## REMARKS

Several amendments have been made to the drawings. These amendments are shown in the accompanying Replacement Sheets and also in the Annotated Sheets Showing Changes which are attached hereto as Appendix A. It is noted that the set of drawings mailed on December 27, 2001 along with the RESPONSE TO NOTICE TO FILE MISSING PARTS OF NONPROVISIONAL APPLICATION had some handwritten notes thereon pertaining to some of the drawing corrections being made by this Amendment. Due to the large number of drawing sheets in this case (i.e., 180 drawing sheets), neither Applicants' attorneys nor the Patent Office noticed this inadvertent oversight. Applicants' attorneys intended to make the corrections that were indicated on the drawings by the handwritten notes in response to the first Office Action not in the RESPONSE TO NOTICE TO FILE MISSING PARTS OF NONPROVISIONAL APPLICATION.

## AMENDED SHEET SHOWING CHANGES

FIG. 62E

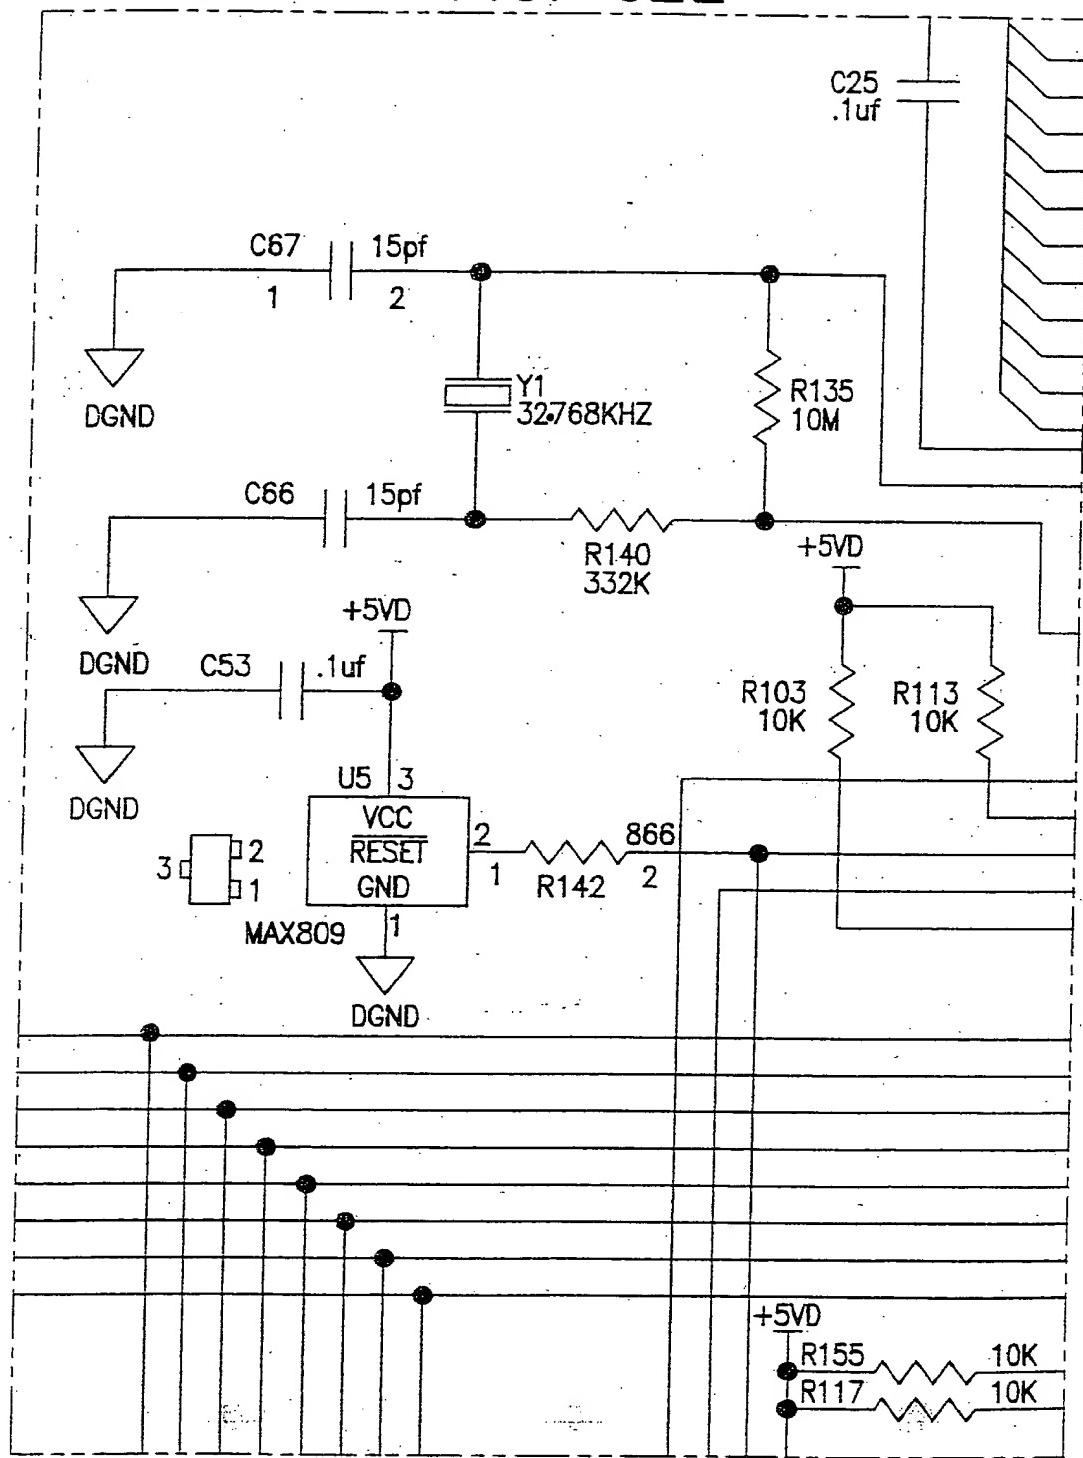
Figs. 56 and 58 have been amended to change the word "where" to "were" to correct the typographical error in each of these Figs. In Fig. 62E, 32768 kHz is replaced by 32.768 kHz to match the correction made to the specification. In Fig. 62G, a missing line segment to connect up to capacitor C49 has been added. In Fig. 62H, a line has been added atop CS10 on the pin 10 designation and QSO has been replaced by DSO on the pin 77 designation. In Fig. 62I, the pin 69 designation has been changed from PSC0/SS/PQS3 to PSC1/PQS4, the pin 68 designation has been changed from TXD\PQS7 to PSC0/SS/PQS3 (with a line above the SS), and the pin 75 designation has been changed from ADDR0 to TXD/PQS7. In Fig. 62R, a line has been added over VFD\_CE. In Fig. 63F, MEMA (with a line thereover) has been replaced by MEMR (with a line thereover). In Fig. 64M, a line segment connecting up the output of the lowermost amplifier (designated as U29) with the associated node has been added. In Fig. 66 J, "M SO" has been replaced with MISO.
